RE: Request for clarification on BT-2RCL specifications

Subject: Re: Request for clarification on BT-2RCL specifications

3.0 Transducer Equivalent Circuit: Acoustic Transmit Channel.

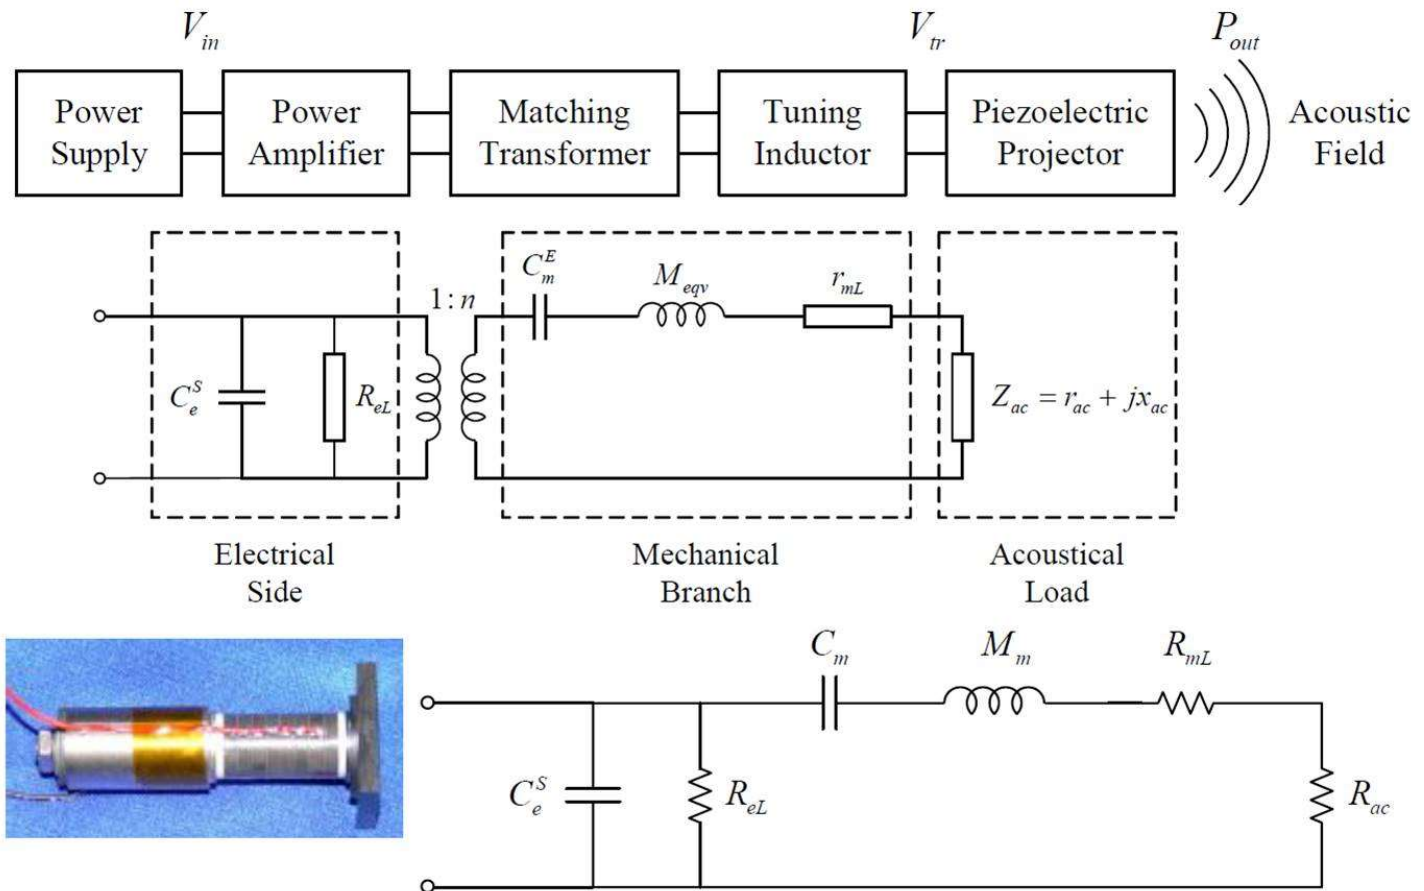
Yes it does...bring power factor to unity...but modeling the load as just a capacitor is not adequate except at low frequencies (but it is not used as a projector at low frequencies).

It's an electro-mechanical-acoustical circuit.

Probably for an undergrad project you can consider it at resonance...where the mass reactance cancels the stiffness reactance.

Figure 8.7.1 Sound absorption at $T = 5^\circ\text{C}$ and $Z = 0$ km in freshwater and seawater ($\text{pH} = 8$, $S = 35$ ppt).

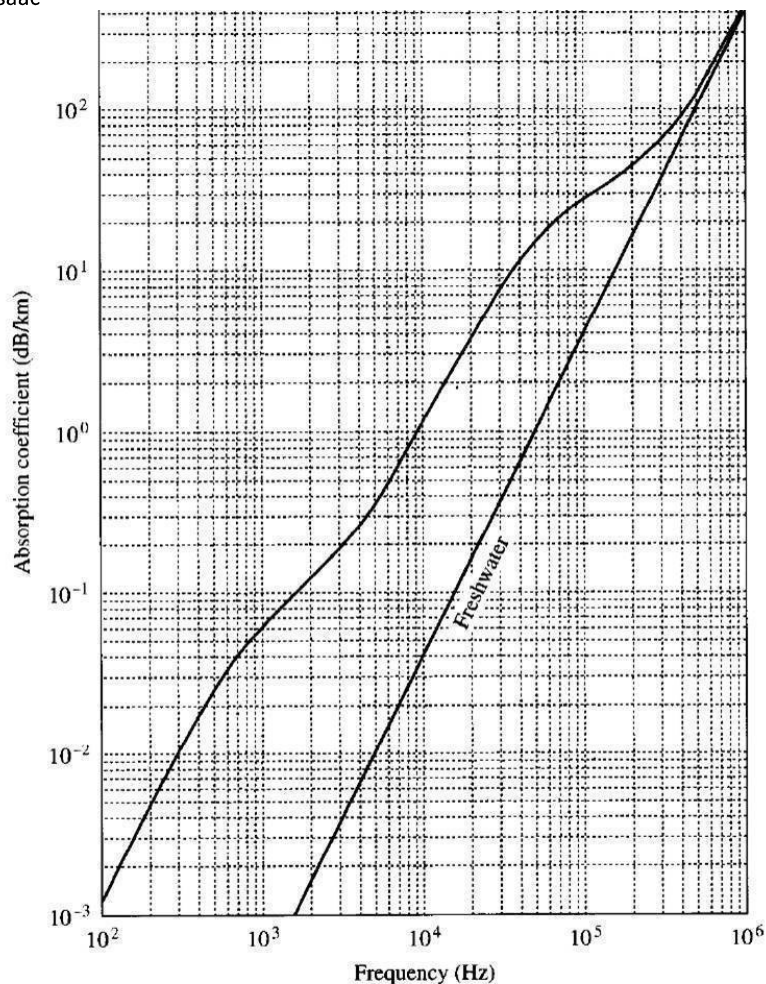
If I assume spherical spreading and losses at 30kHz $20 \log r + \alpha r = 60 + 8$ dB

REPLY: I get

180 dB - 68 dB = 112 dB re 1 uPa

That will produce a voltage of

OCVS = -190 db re 1V/uPa + 112 dB re 1 uPa = -78 dB re 1 V rms. That is -18 dB re 1 mV rms or 126micro-V RMS
